PRODUCT CHANGE NOTICE

Data Sheet Specification Change for Intersil Product ISL55015IEZ-T7

**Refer to:
PCN13015**

Date: February 19, 2013

P6.049B

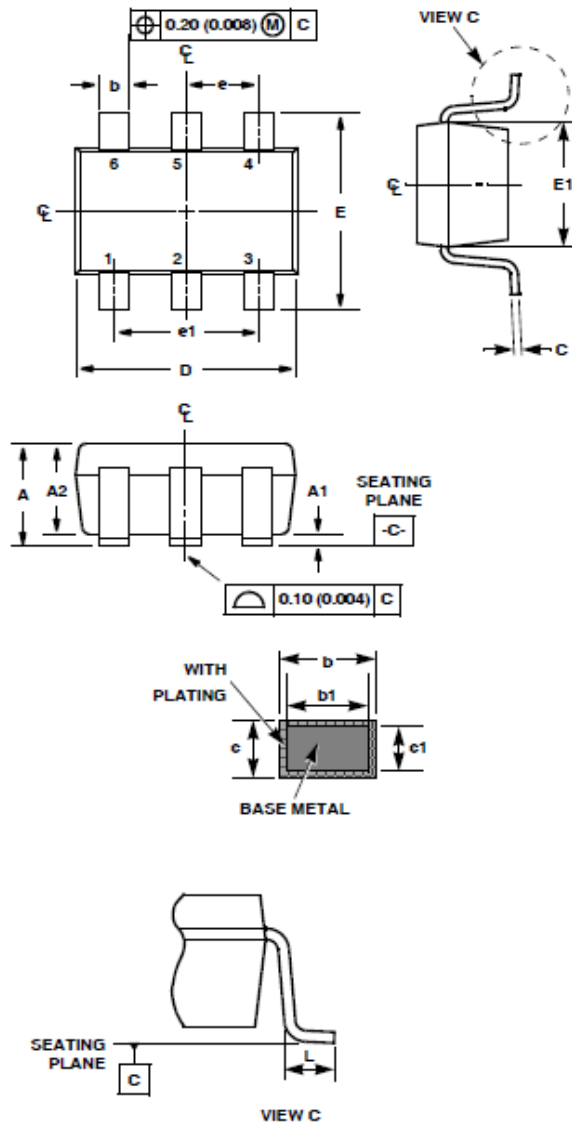
- Corrected the ESD level for Machine Model in the *Absolute Maximum Ratings* section.
- Updated Theta JA and added Theta JC in the *Thermal Information* section.
- Output Power at 1dB Compression (P1dB) parameter limits changed in the *Electrical Specifications* table.
- Replaced the *Package Outline Drawing (POD)* to align with product change notice PCN12091.

SYMBOL	MILLIMETERS		NOTES
	MIN	MAX	
A	0.80	1.00	-
A1	0.000	0.09	-
A2	0.80	0.91	-
b	0.15	0.30	-
b1	0.15	0.25	-
c	0.08	0.25	6
c1	0.10	0.15	6
D	1.85	2.25	3
E	2.30 BSC		-
E1	1.15	1.35	3
e	0.65 Ref		-
e1	1.30 Ref		-
L	0.21	0.44	4
N	6		5
